Project	IEEE 802.16 Broadband Wireless Access Working Group < http://ieee802.org/16 >		
Title	MAC Frame numbering and synchronization		
Date Submitted	2006-07-13		
Source(s)	Mariana Goldhamer Alvarion 21, HaBarzel Street Tel Aviv, Israel	Voice: Fax: mailto: mariana.goldhamer@alvarion.com	+972 544 22 55 48 +972 3 6456241
Re:	IEEE 802.16h-06/015 – Working Group Review		
Abstract	Clarifies the MAC Frame sync and numbering issues

MAC Frame numbering and synchronization

Fig hy: The first 4 slots of the Control Channel

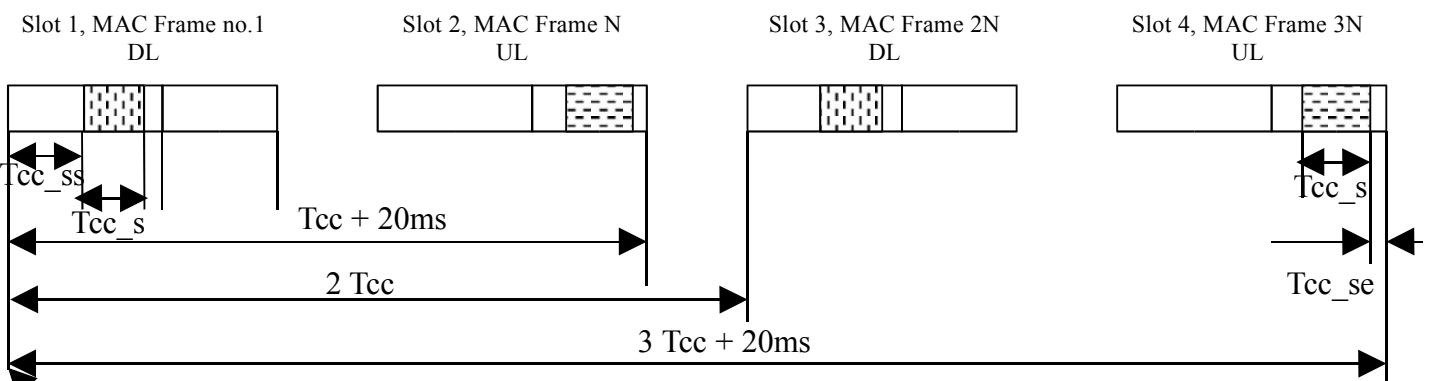
The first 4 slots of the Control Channel are shown in the fig. hy.

The positioning of the DL/UL Control Channel slots is done in a way that will keep their DL/UL characters for a MAC Frame duration of 5,10 and 20ms. The interval between two consecutive DL slots is $2T_{cc}$ and is defined in Chapt.10.5.2.
